PLANNING COMMISSION  
DATE: 6/22/15  
AGENDA ITEM: 4A – PUBLIC HEARING  
CASE # 2015-19

ITEM: Diedrich Property Townhouses (Lennar) – Preliminary Plat and Conditional Use Permit

To: Kyle Klatt, Planning Director  
From: Jack Griffin, P.E., City Engineer

Re: Diedrich Property – Preliminary Plan Review

STORM SEWER

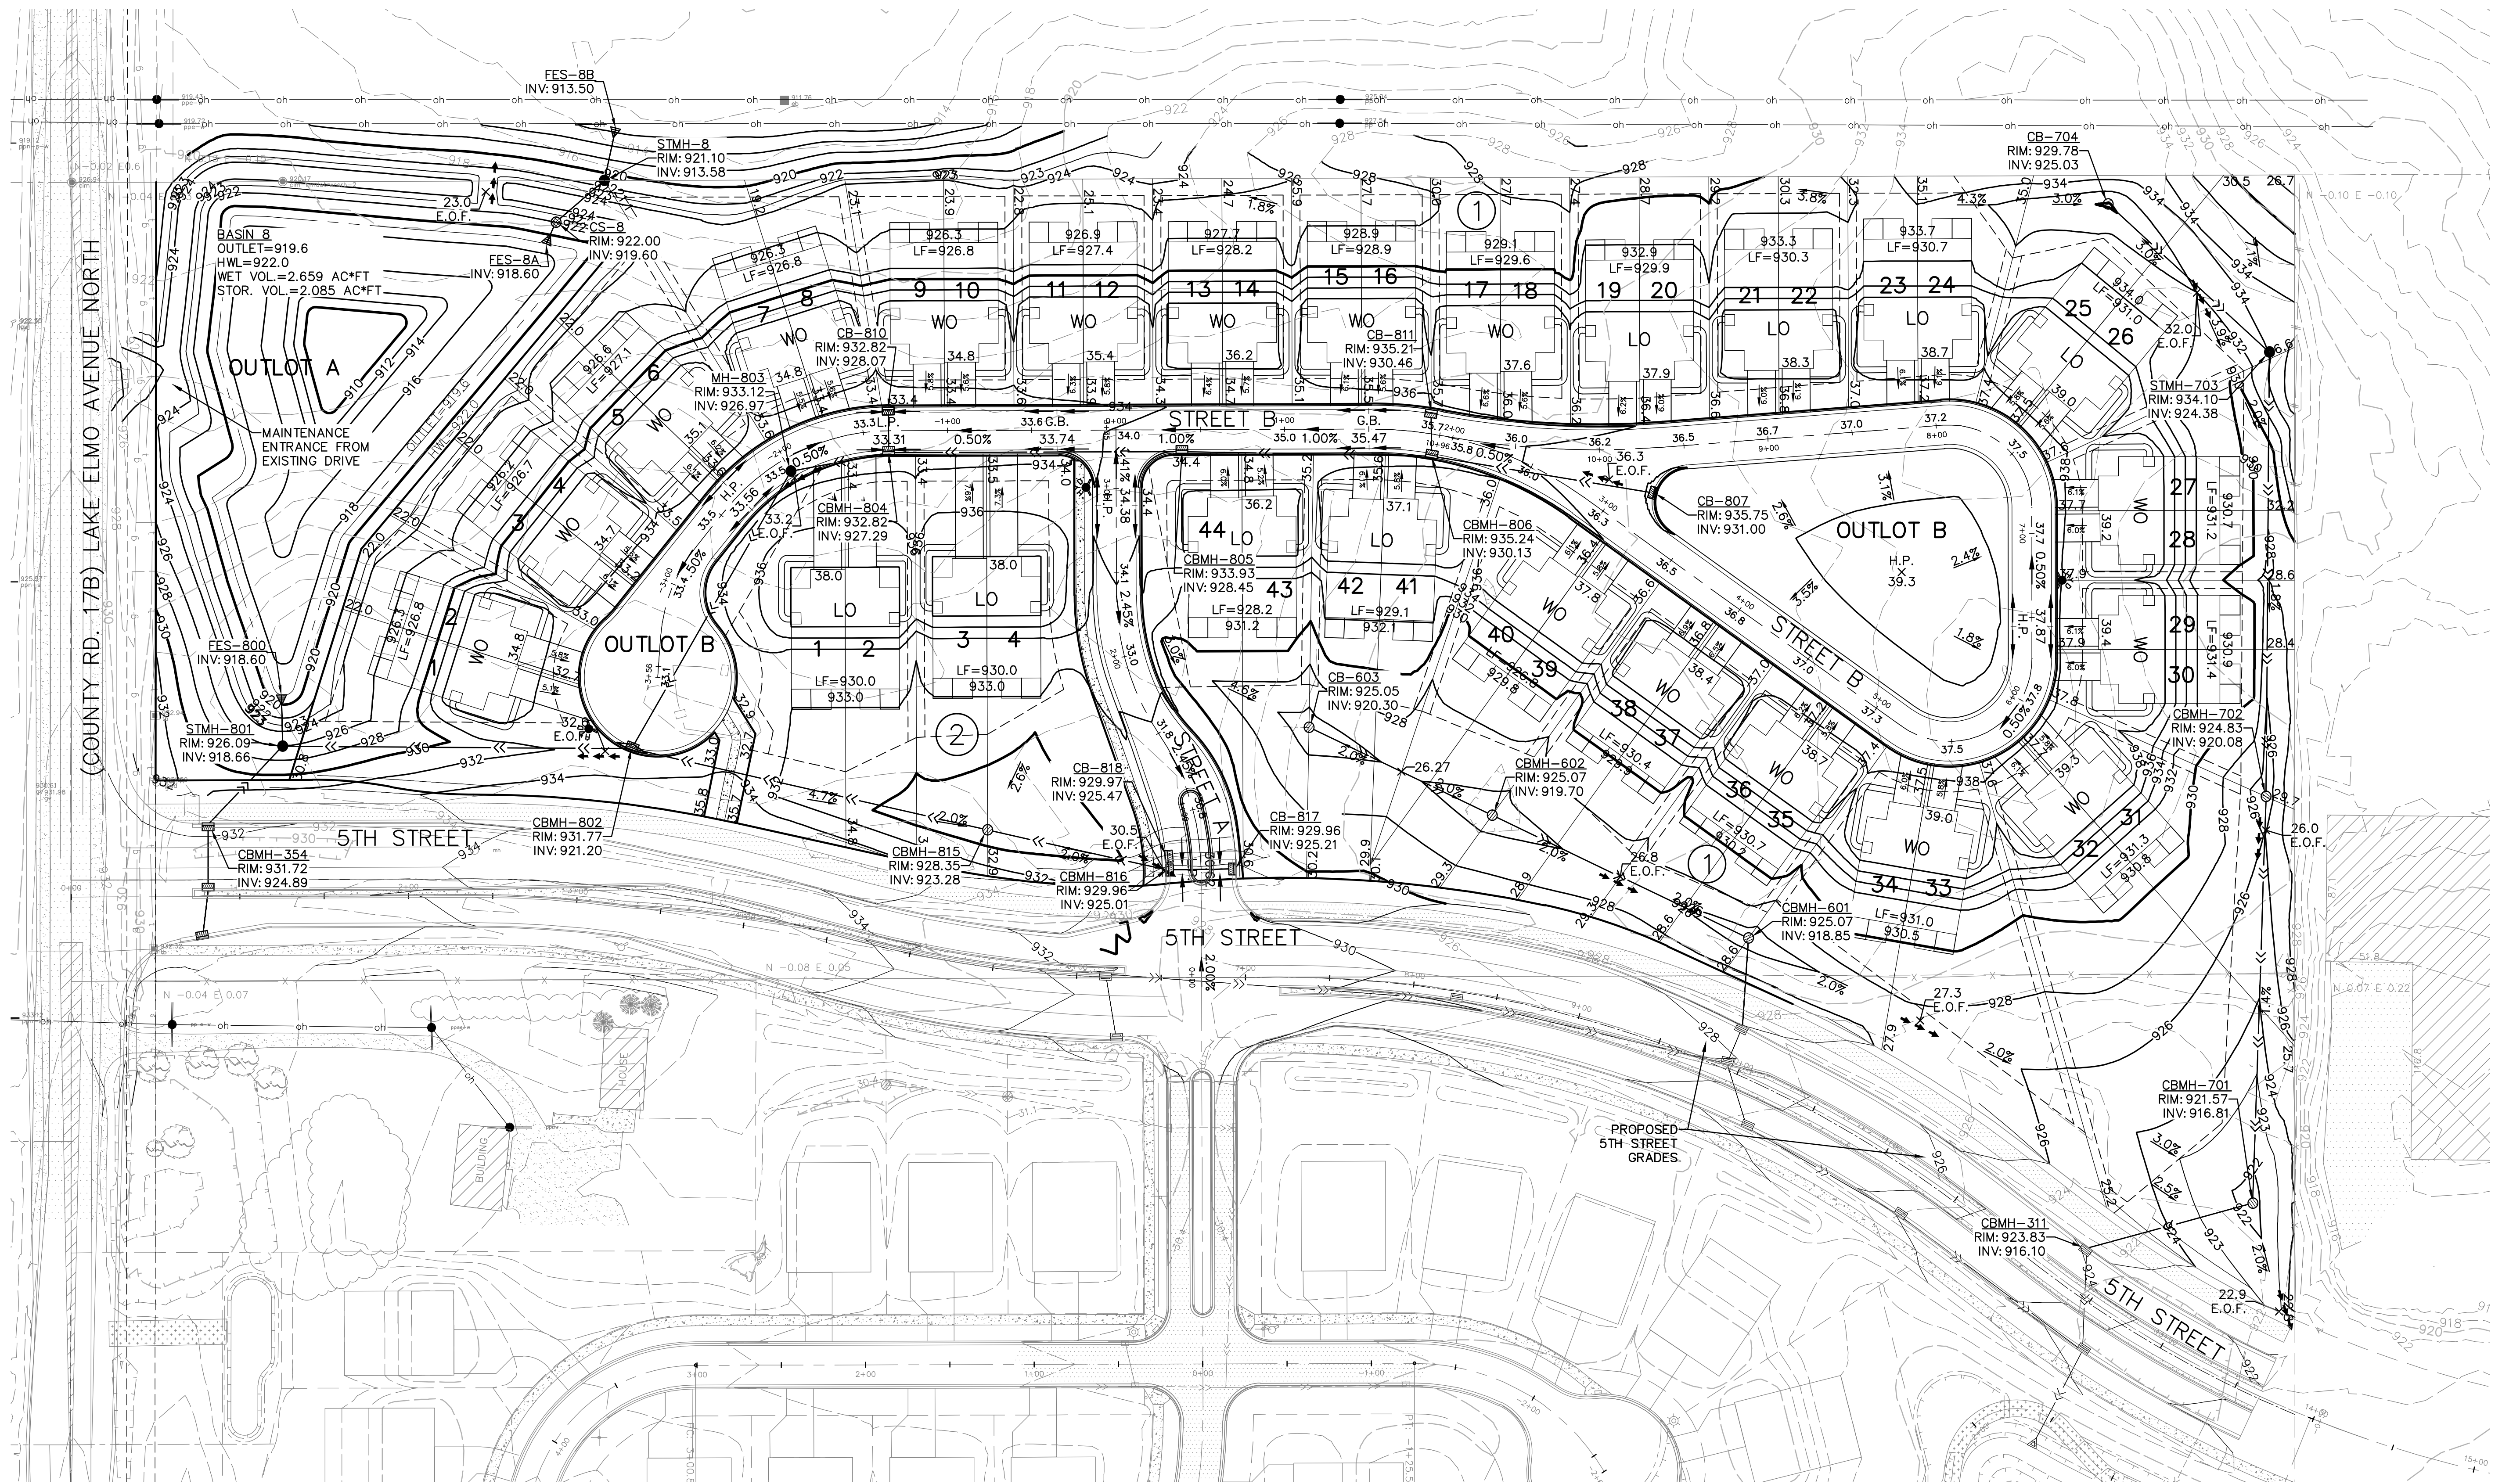
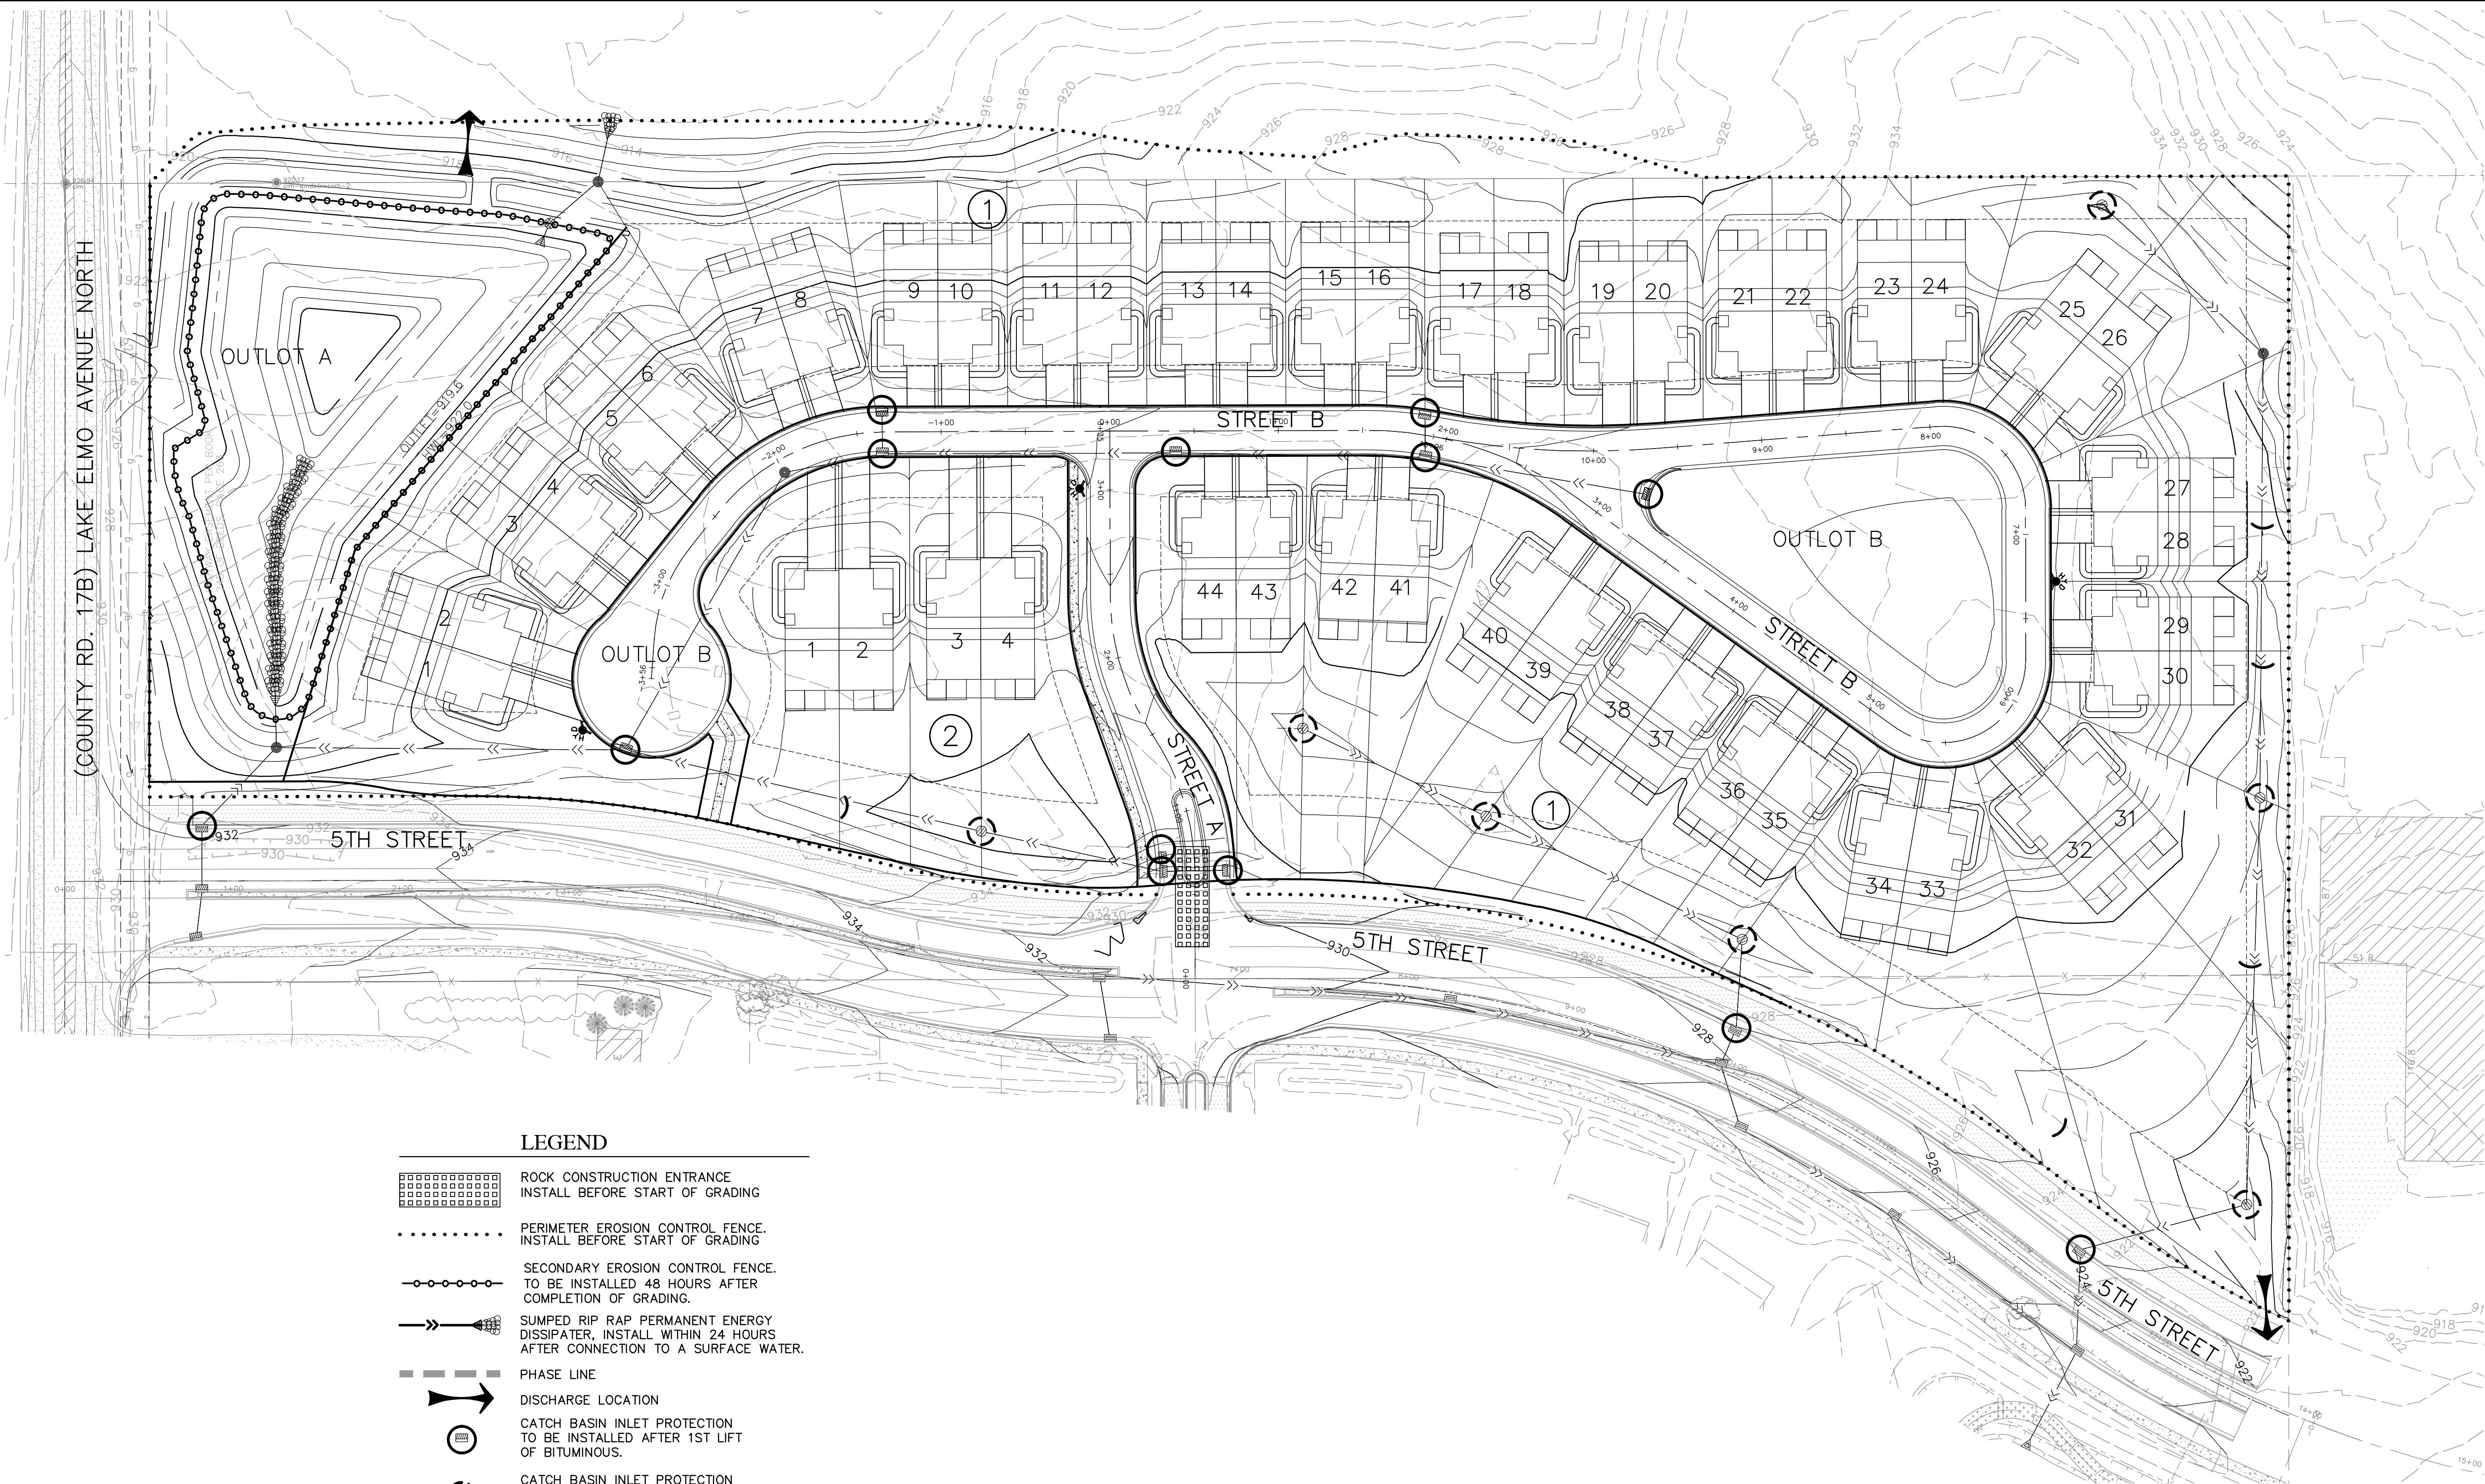
- The maximum allowable curb run along streets without catch basins is 350 feet. Catch basins should be added along Street B, easterly cul-de-sac to maintain maximum curb run of 350 ft.
